NOTICE OF DECISION

CLASS 3 SITE PLAN REVIEW / CLASS 2 ADJUSTMENT CASE NO.:
SPR-ADJ21-33

SUMMARY: A proposal to construct a new building and site improvements at an existing shopping center.

BEFORE THE PLANNING ADMINISTRATOR OF THE CITY OF SALEM

1 Sunnyslope Site Plan
0' 10' 20' 40' 60' 80' 100' 120' 1" = 40'-0"

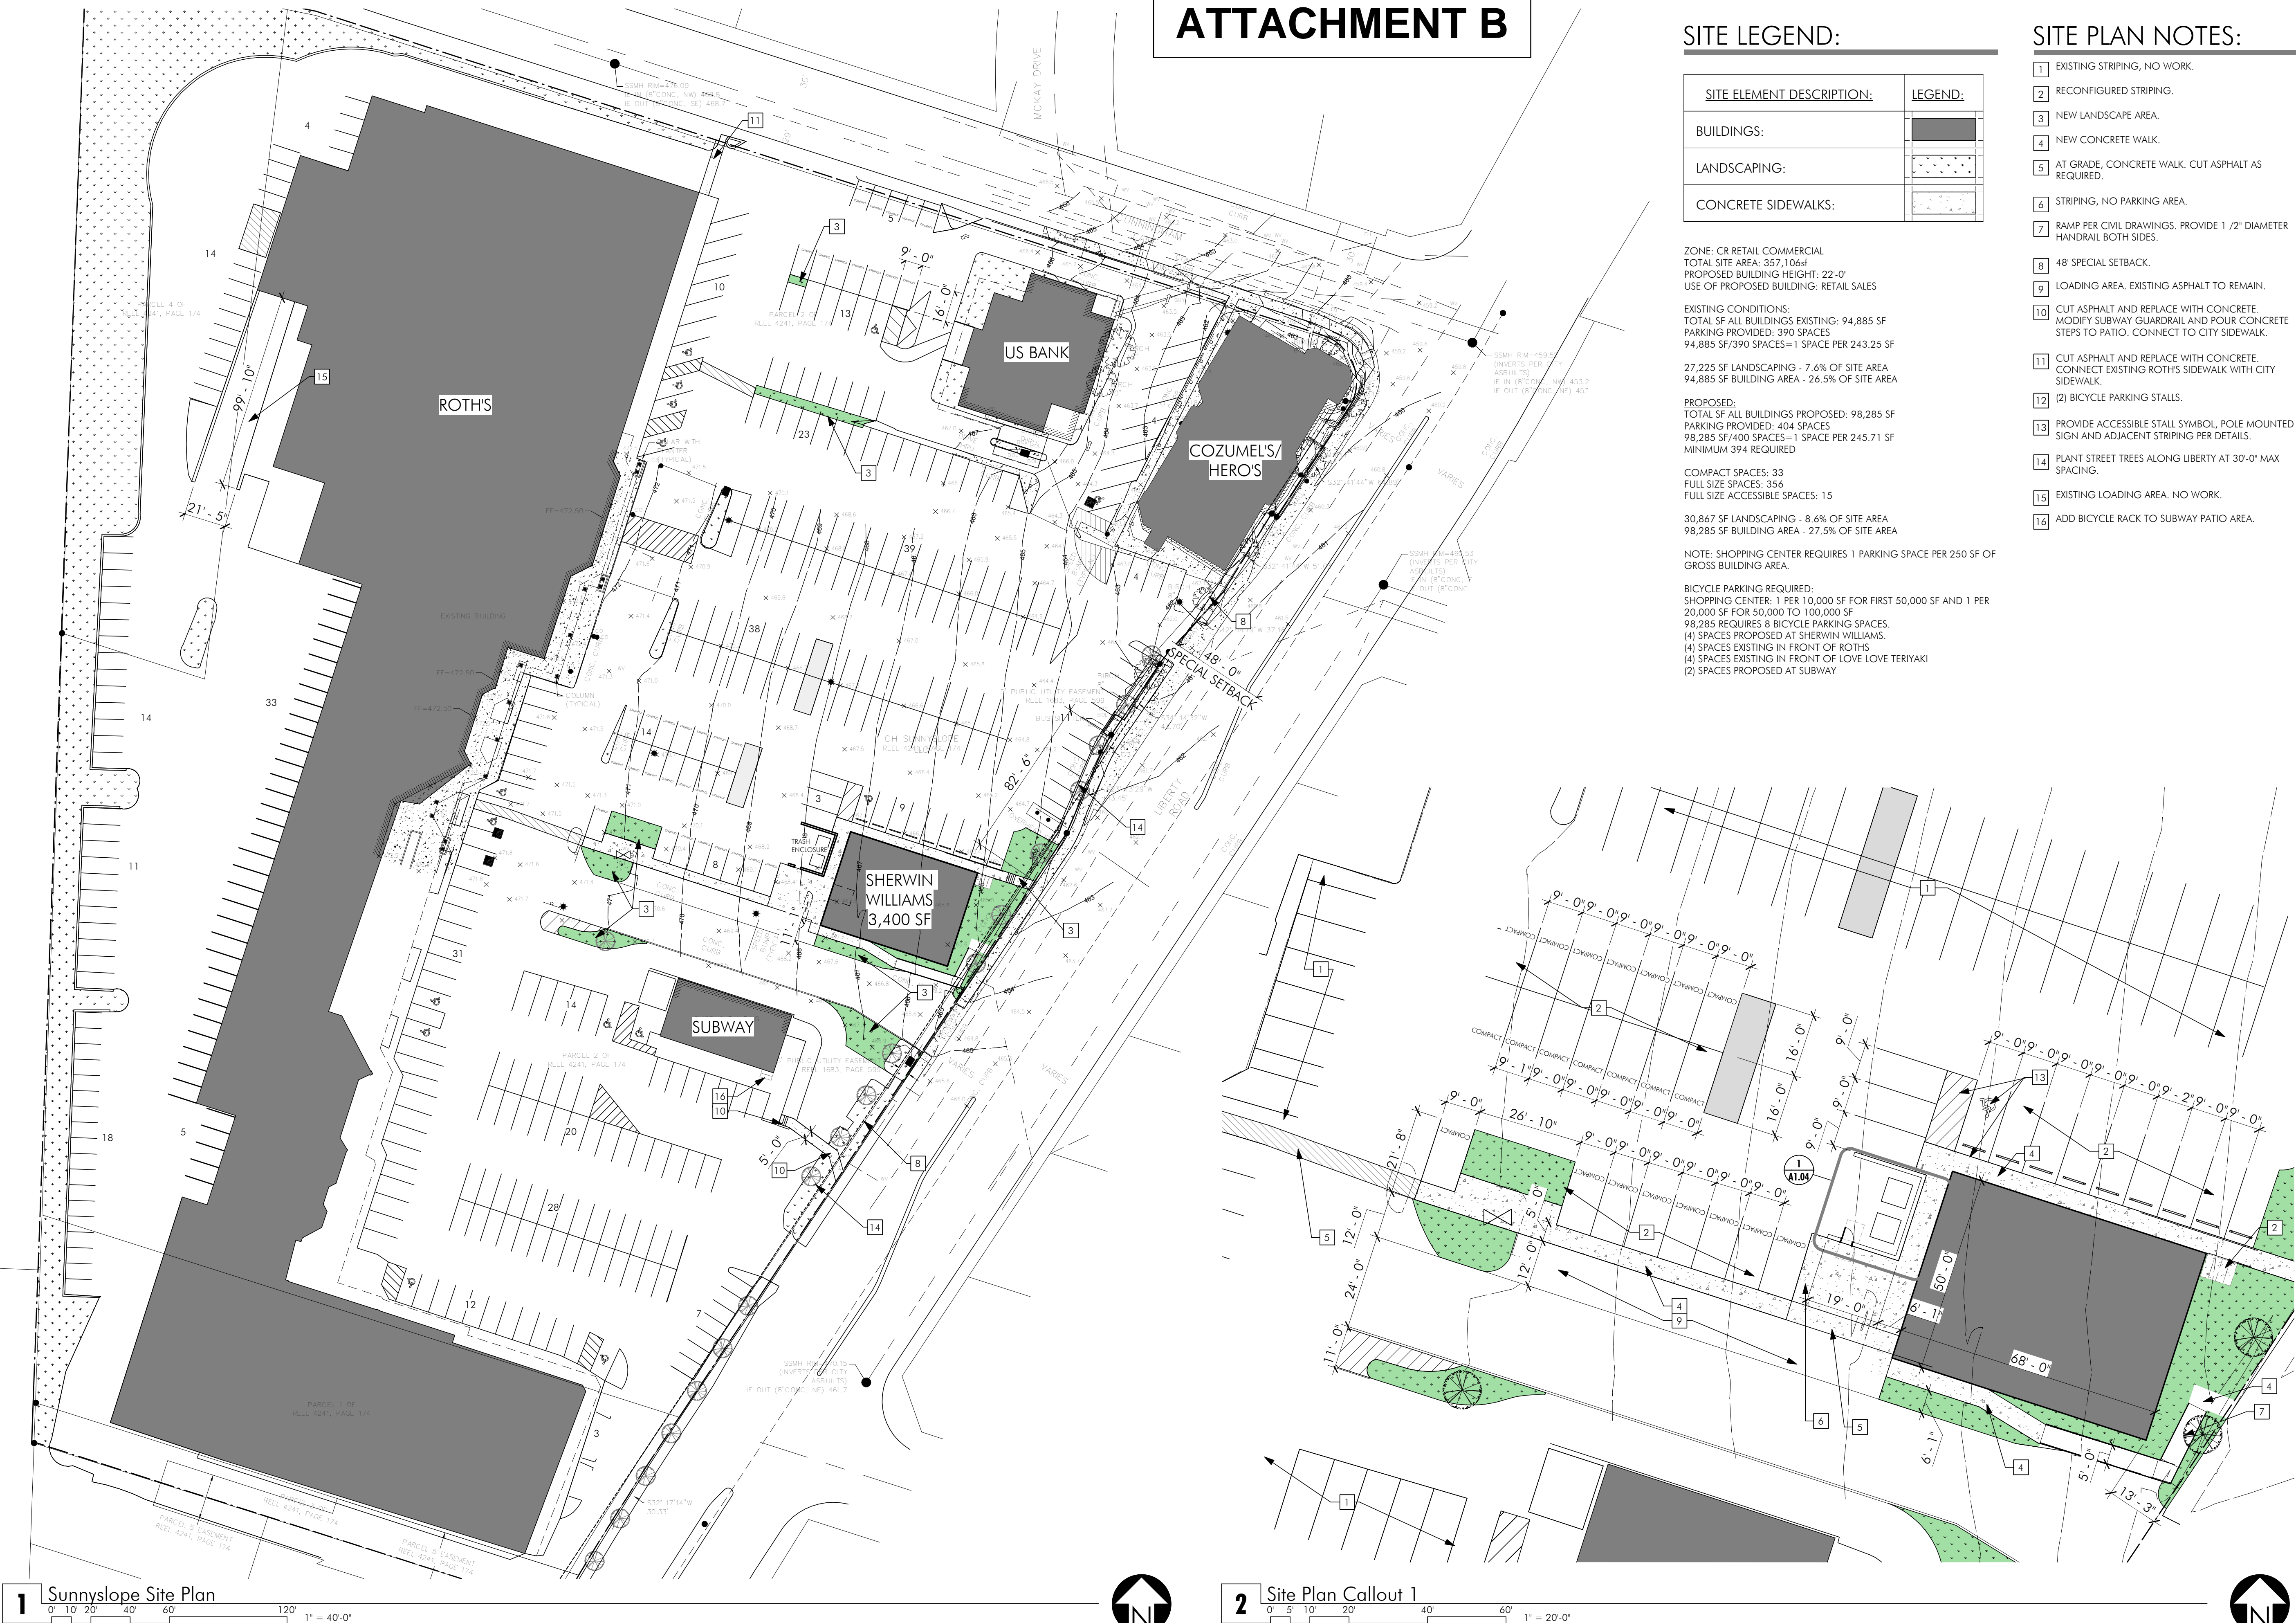
- Cherriots (Salem Area Mass Transit District) requested that the proposed tree northeast of the existing transit stop be removed from the proposal, as it could block visibility of the transit stop for bus operators.

Finding: The proposed site plan shows one row of eight compact spaces west of the proposed building which require wheel stops but none are shown. To ensure the proposal provides wheel stops or extended curbs along required pedestrian connections to prevent the encroachment of vehicles onto pedestrian connections, the following condition of approval shall apply:

Staff notes the main building within the shopping center is L-shaped, with most of the building set back away from Liberty Road and one corner of the building extending toward Liberty Road, with an existing pedestrian path wrapping around the front of the building. By connecting the corner of the building near Liberty Road to the public sidewalk along this street, this would further break up the site's large off-street parking areas and provide reasonable pedestrian circulation into, through, and out of the development site. Furthermore, it appears this would require the elimination of only one parking space, thereby limiting the impact to the rest of the site. The following condition of approval shall apply:

Condition 1: Landscaping shall not block visibility of the transit stop along the property's street frontage as viewed from the southbound travel lanes of Liberty Road S. Any landscaping planted within the area directly northwest of the transit stop shall not be taller than 30 inches above curb level.

Condition 5: Provide a pedestrian connection between the main building in the shopping center and Liberty Road S, located in the approximate area south and east of the southernmost ADA parking stall. The pedestrian connection shall meet the design and materials standards of Salem Revised Code 800.065(b).

- Condition 3:** Wheel stops or extended curbs shall be provided within the row of eight compact spaces west of the proposed building.
- Condition 4:** Replace the sidewalk along the westernmost driveway approach along Cunningham Lane S.
